SUPPLEMENT TO ENVIRONMENTAL REPORT  
MOAB, UTAH FACILITY  
FOR ATLAS MINERALS

7/9/74

Dames & Moore Job No. 5467-003-06

This report presents the results of our additional engineering studies of the Atlas Minerals uranium milling facility near Moab, Utah. This report was prepared in response to the 27 questions posed by the Atomic Energy Commission in a letter dated January 25, 1974 concerning the "Environmental Report, Moab, Utah Facility," by Atlas Minerals Division of Atlas Corporation, dated August 31, 1973. A previous study by Dames & Moore entitled "Report of Engineering Studies, Tailings Pond Embankment System, Moab, Utah, For Atlas Minerals," dated March 28, 1973 was included in the environmental report as Appendix A. Information and data presented in these reports were drawn upon for this response.

PLOT PLAN

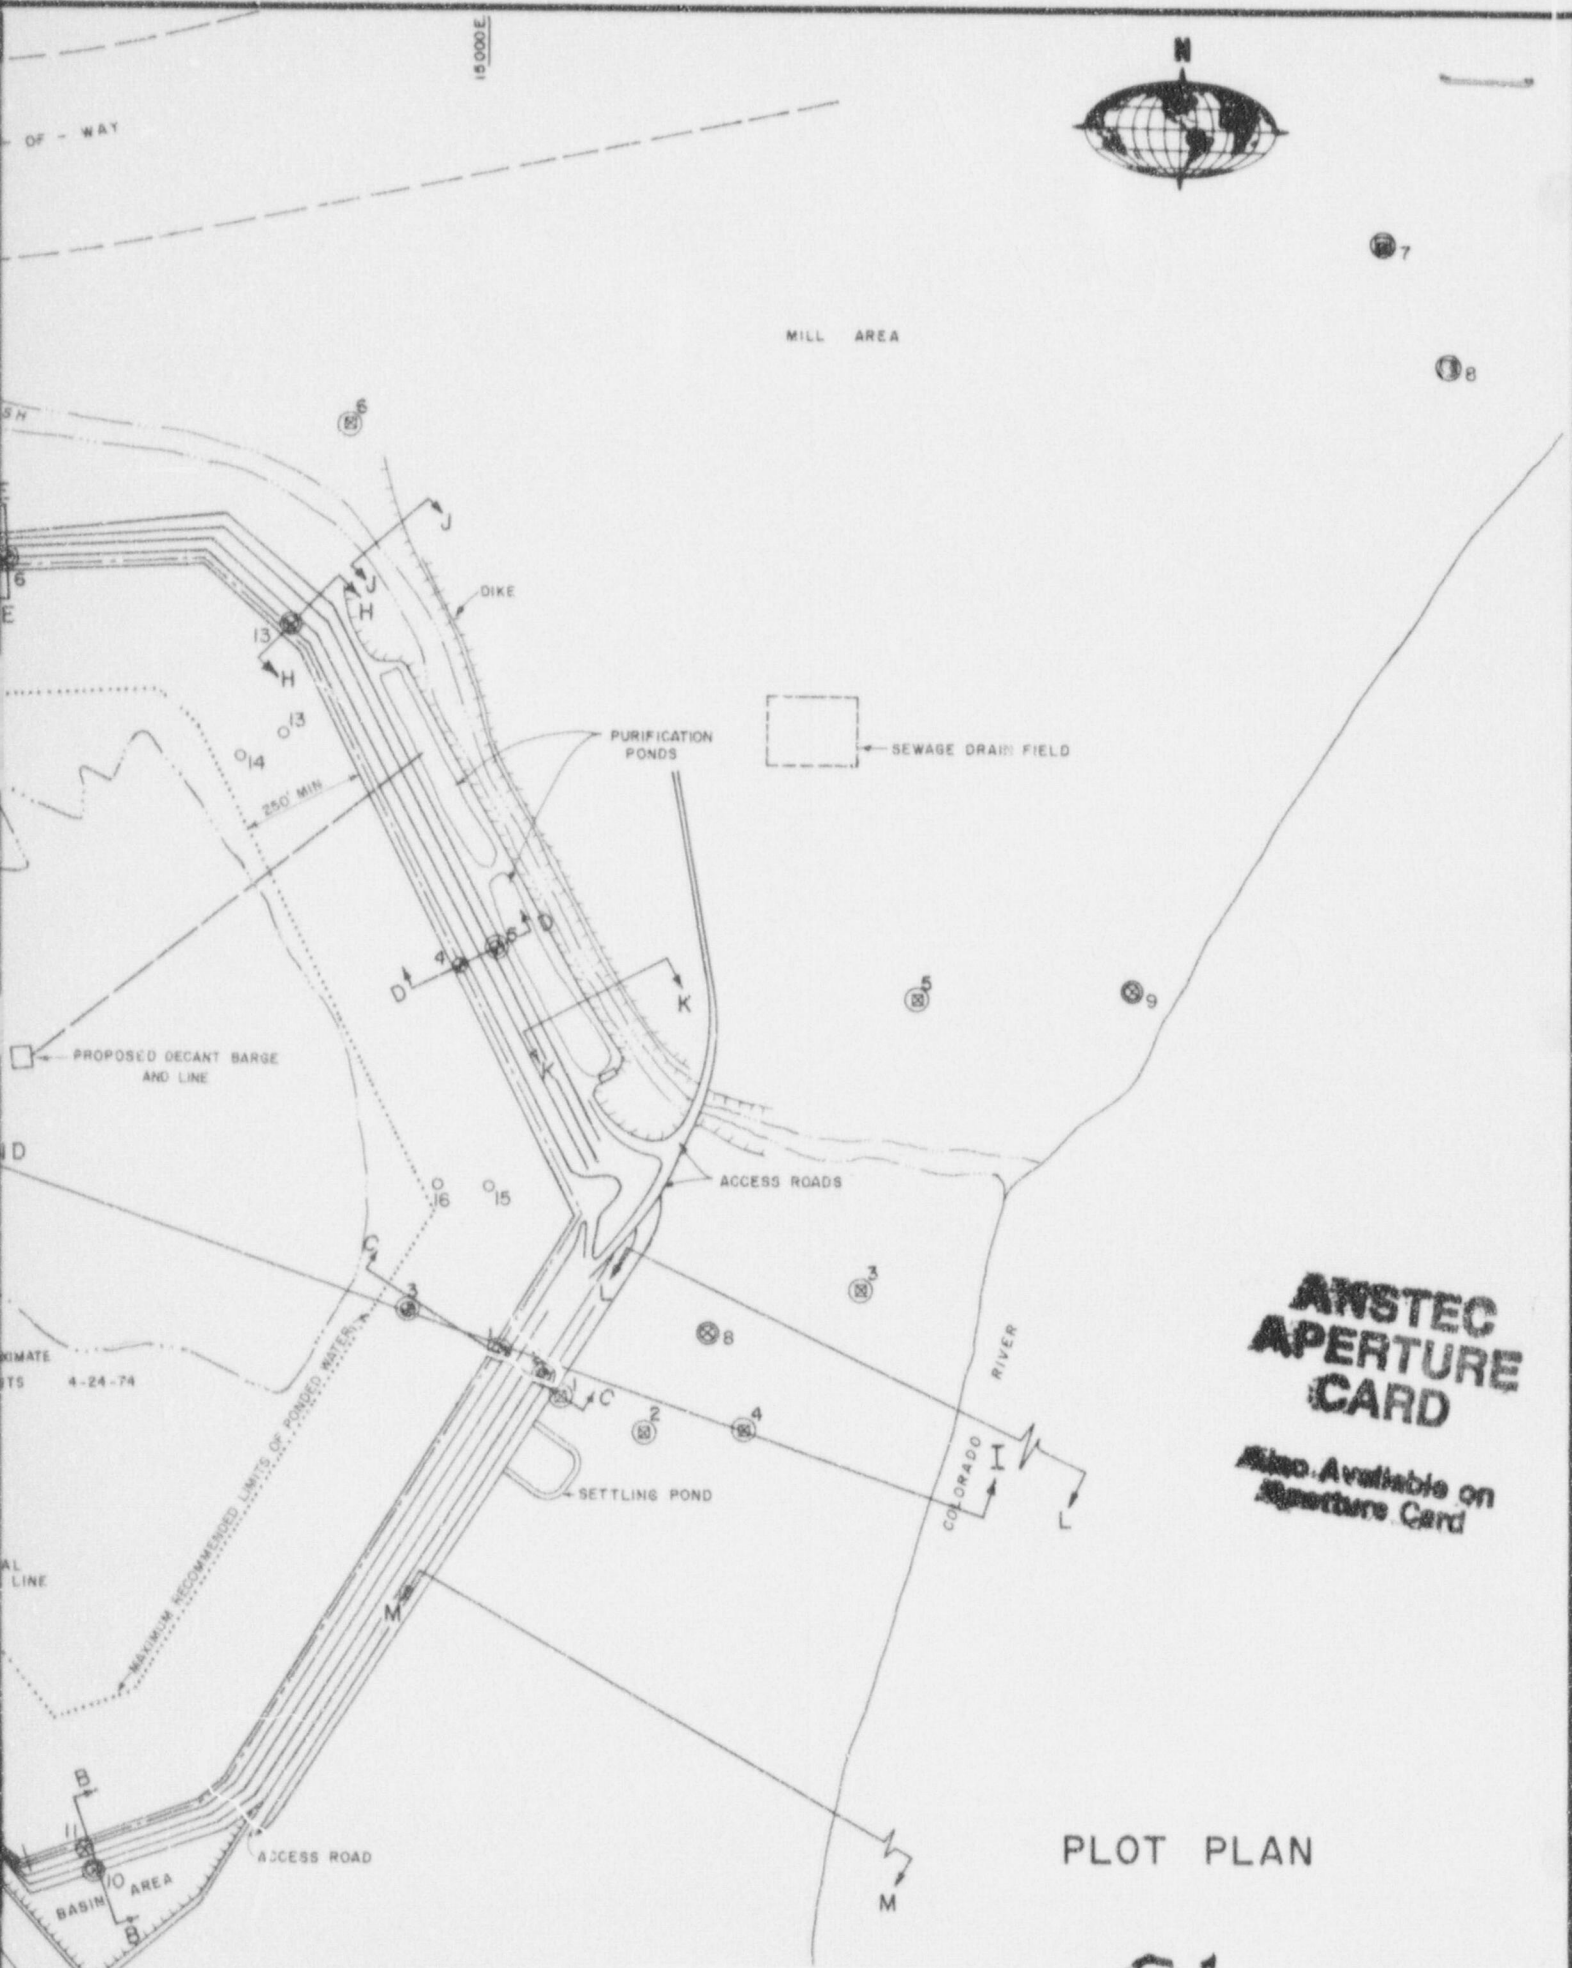
9.15 REPLY TO A.E.C. QUESTION 14:

The logs of additional borings drilled in the embankment and site vicinity are presented in Appendix A of this report. The locations of the borings are shown on Plate 2, Plot Plan. Additional cross-section and results of the stability analyses calculated for these sections are presented in graphical form on Plates 6A through 6F.

The location of the discharge line referred to on page 6 of Appendix A of the Atlas Minerals Environmental Report is shown on Plate 2, Plot Plan. The line is referred to as "Existing Tailings Discharge Line."

The discharge and decant barge line are shown on Plate 2, Plot Plan, of this report. The discharge and decant operations are discussed in Section 7.1.2 and 7.1.3 of this report.
